# **Leviathan Gas Platform**

## **Emission Permit Review**

Noble Energy submitted a "Request for Emission Permit" to the Israel Ministry of Environmental Protection in the fall of 2018, and subsequently submitted a revised Request for Emission Permit in January 2019. This report refers only to the revised Request for Emission Permit submitted in January 2019.

Homeland Guards, a non-profit organization based in Zichron Yaacov Israel, contracted with Ramboll Corp. to review the revised Request for Emission Permit and provide comments on the accuracy, completeness and reasonableness of the permit request.

**Figure 1. Cumulative distribution of annual NOx emissions for offshore platforms in the Gulf of Mexico.**

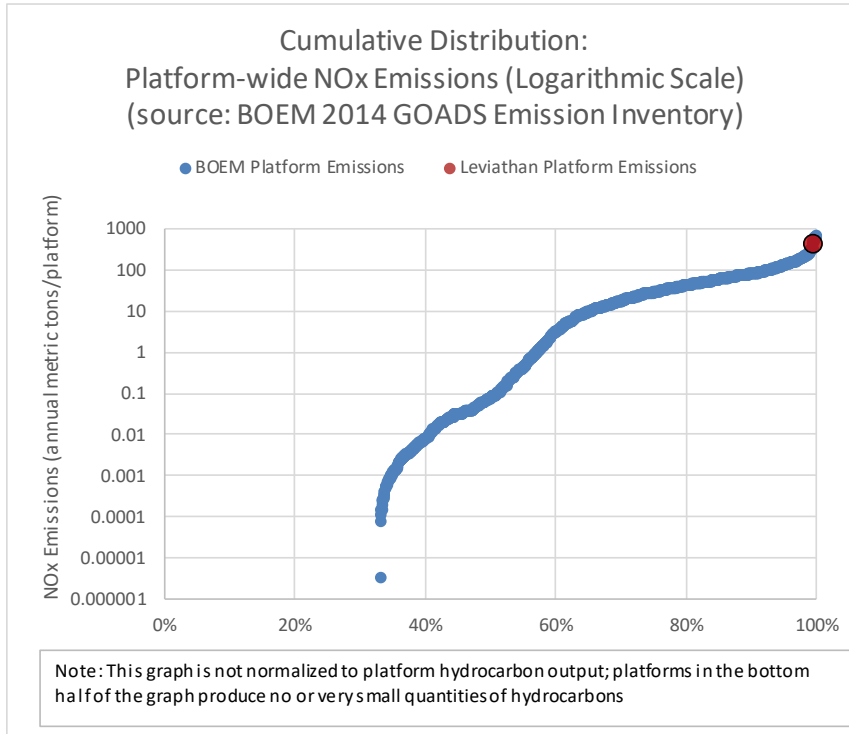
Figure 1 suggests that the Leviathan platform would be near the very highest percentile for NOx emissions, similar to the less than 5% of the highest-emitting platforms in the Gulf of Mexico. By comparison, Figure 2 suggests that approximately 30% of platforms in the Gulf of Mexico would have higher VOC emissions than the Leviathan platform.

This suggests that NOx emissions from the Leviathan platform, as described in the request for emission permit, are similar to the largest, highest-emitting platforms in the U.S. Gulf of Mexico development area. Similarly, VOC emissions are comparable to the largest 30% of platforms in the Gulf of Mexico. Based on discussions with BOEM, the VOC emissions from the 70% of platforms below those of the Leviathan platform in the GOADS database are from platforms with very little gas production or that are otherwise out of operation or idled<sup>9</sup>. This suggests that for a high gas production platform such as the Leviathan platform, much larger VOC emissions would be expected than those described in the request for emission permit. Some of the comments made in section 2.1 above, if addressed properly in the request for emission permit, would lead to an increase in the VOC emission inventory for the proposed platform. We also note that the control system proposed here is novel and its operation has not been demonstrated for such a large scale operation. As noted above, close monitoring of this system is strongly recommended, particularly in the initial phase of operation of the platform, to ensure that the control efficiency as described in the request for emission permit is actually achieved.
